LOST CREEK PROJECT

**RESPONSES TO WDEQ/LQD COMMENTS
of 8/26/08
for**

**APPENDIX D-5
GEOLOGY**

**RESPONSES TO WDEQ/LQD COMMENTS
of 8/26/08**

LOST CREEK PROJECT
 ILLUSTRATION OF THE CHARACTER OF
 AQUICLUDES AND AQUIFERS

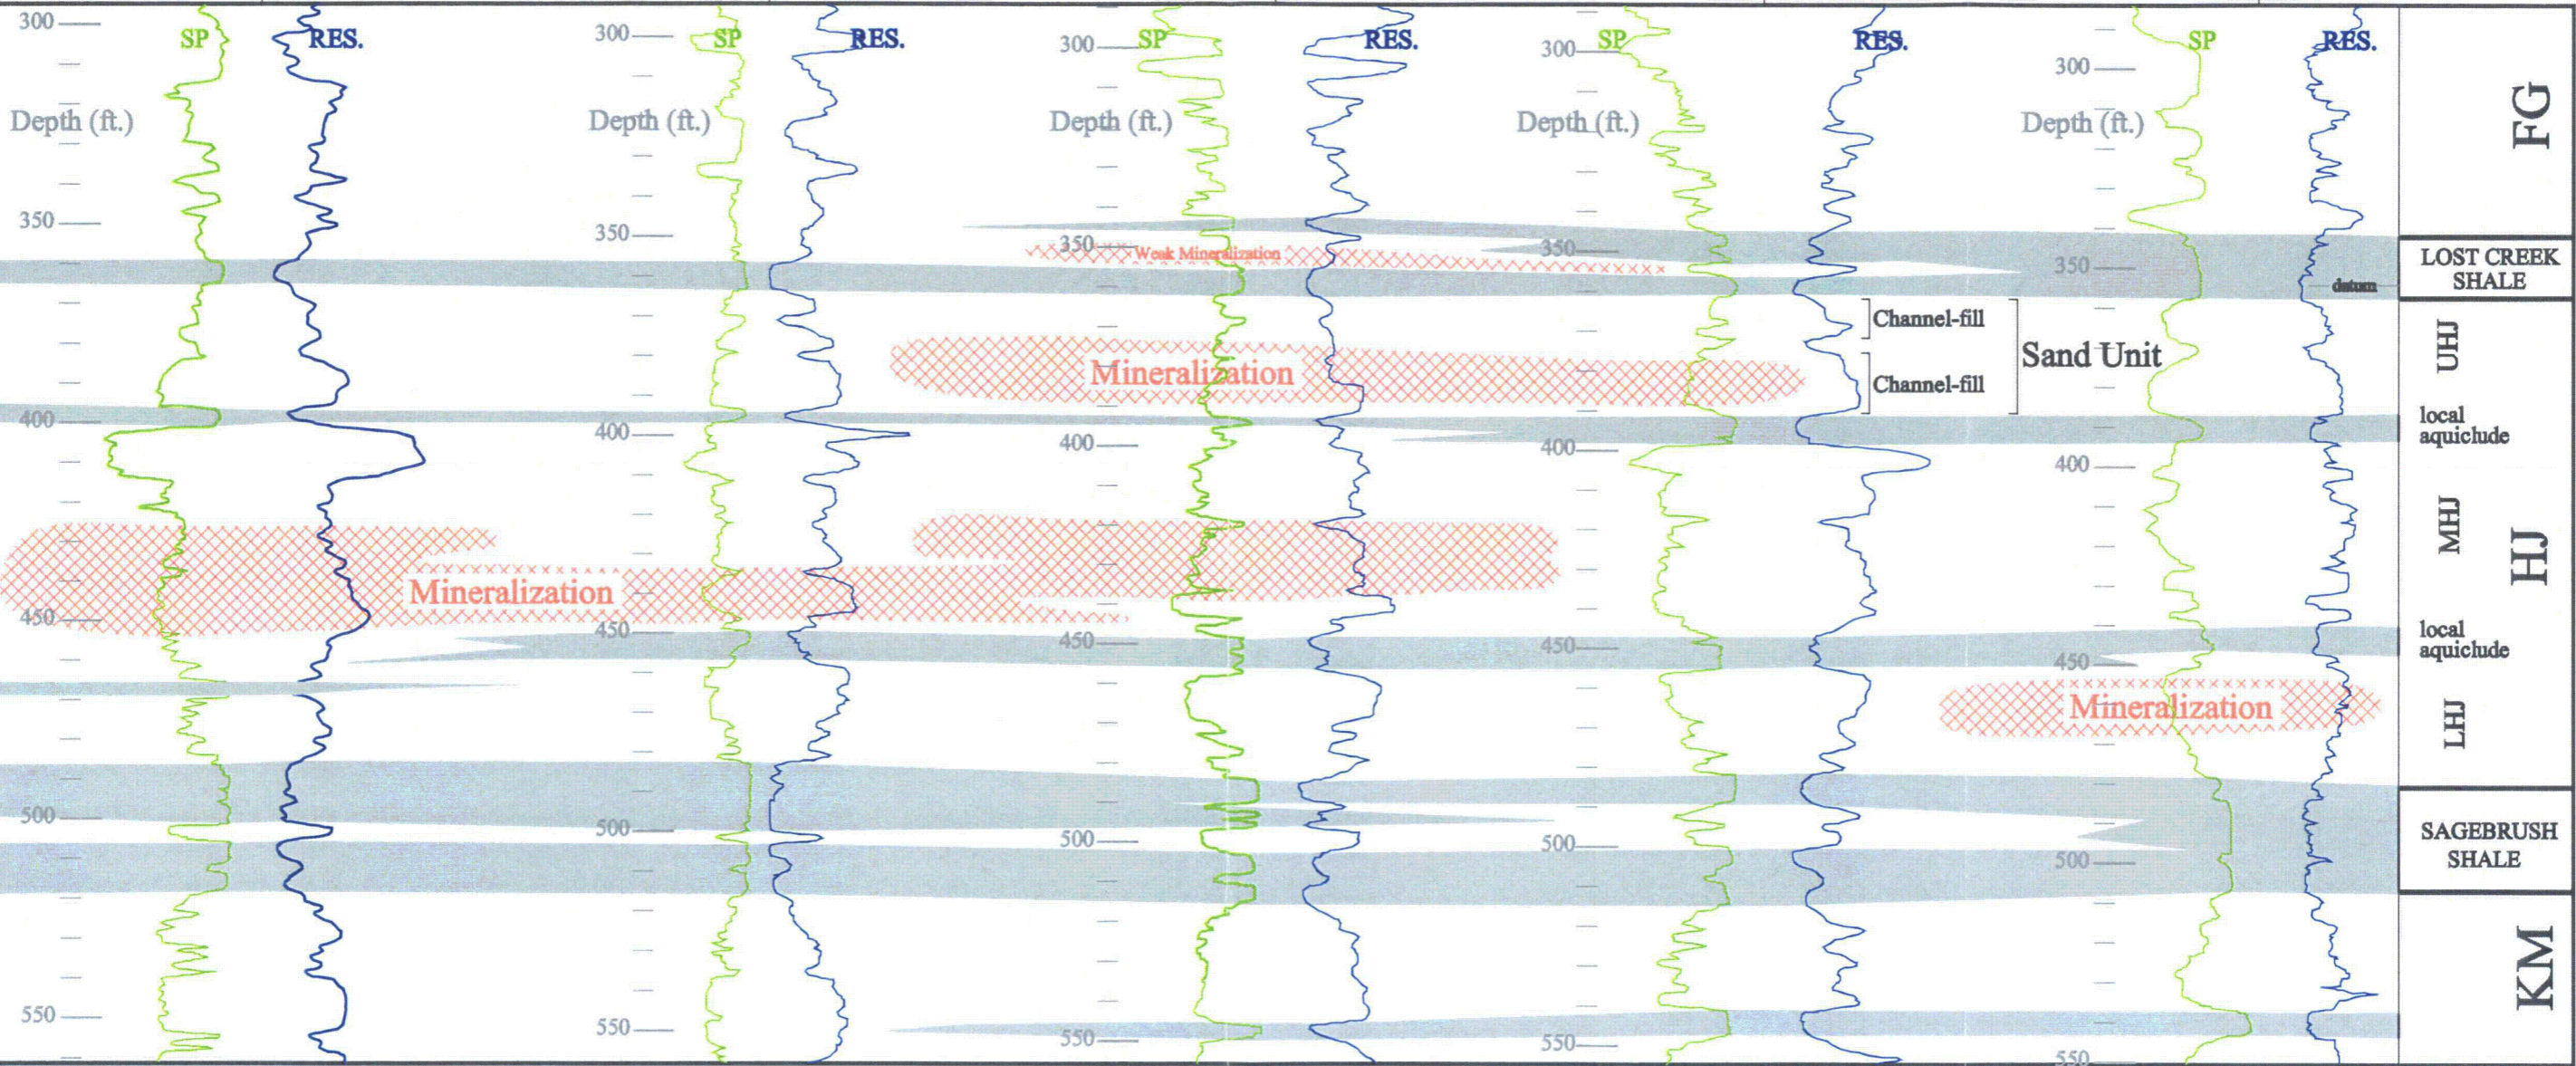
- 11) ***Plates D5-1b through D5-1e. Plates D5-1b – D5-1e show many places where the Sage Brush Shale has mineralized zones of ore, e.g. TG19-20, TG68-20, TG12-20, TG58-20, TG2-10, TG9-17, TG10-17, and TG11-17. The presence of mineralized zones within the Sage Brush Shale brings to question the ability of this unit to act as an adequate aquitard between the LHJ and UKM sands. The Sage Brush Shale is defined as a fine sand and shale unit. How fine is the sand if it had enough transmissivity to be a receiving unit for the Uranium? The overlying Lost Creek Shale also has some minimal mineralization within it. What is the likelihood that these shales could leach out Uranium altering the integrity of the unit. It is requested that the MKM be fully characterized for baseline, north and south of the***

fault, as it may end up being the underlying aquifer that needs to be protected during mining of both the HJ horizon and potentially the UKM horizon. (AB)

Aquifers in the Battle Spring Formation typically consist of thick sequences of multiple, medium to coarse-grained, fluvial channel-fill sands. *Mapable* sand units (for example: the UHJ Sand) may range from five to 50 feet in composite thickness, and typically consist of multiple stacked channel-fill sands. *Aquifers*, in turn, typically consist of multiple stacked sand units. Sand units are commonly separated vertically by locally thick beds of mudstone, claystone, siltstone or fine-grained sands. These interbeds represent local aquitards and aquicludes which can be considered internal to the regional aquifer. Total composite thickness of an aquifer (for example: the HJ Horizon) is commonly in excess of 100 feet.

Aquicludes and aquitards (for example: the LCS or SBS Shales) represent quiescent floodplain and overbank sedimentary environments between channel fill sequences. Generally referred to as 'shales' they are, in essence, sedimentary sequences dominated by mudstone and claystone lithology; but also may include substantial amounts of siltstone and fine-grained sands. These lithologies can exhibit considerable lateral facies changes and interfingering, and are often transitional to the aquifers above or below. As a result, dramatic thickening and thinning of the aquicludes can occur locally. In addition, their upper and lower boundaries are often gradational. Aquicludes may even exhibit localized occurrences of mineralization in the vicinity of lithologic interfingering and facies changes with mineralized sands.

The attached figure (Illustration of the Character of Aquifers and Aquicludes at the Lost Creek Project) details the lithologic changes over a 400-foot section in the central portion of Mine Unit One. Because of the depositional variability of the sediments, one purpose of the more detailed assessments of the geologic and hydrologic conditions in the Mine Units is to provide information that could affect operating and monitoring conditions, e.g., positioning of an overlying monitoring well where the overlying shale is thin. Given the extremely low concentration of uranium mineralization in the shale, even if the uranium were removed through mining, it would not result in any noticeable alteration of the shale's integrity. Also, the uranium mineralization is epigenetic so the structural integrity of the shale was developed before emplacement of the uranium and is therefore independent of the uranium. The shale layers in question are strongly reduced which will largely prevent the oxidation and subsequent dissolution of uranium mineralization even if mining solutions were to come into contact with the uranium.
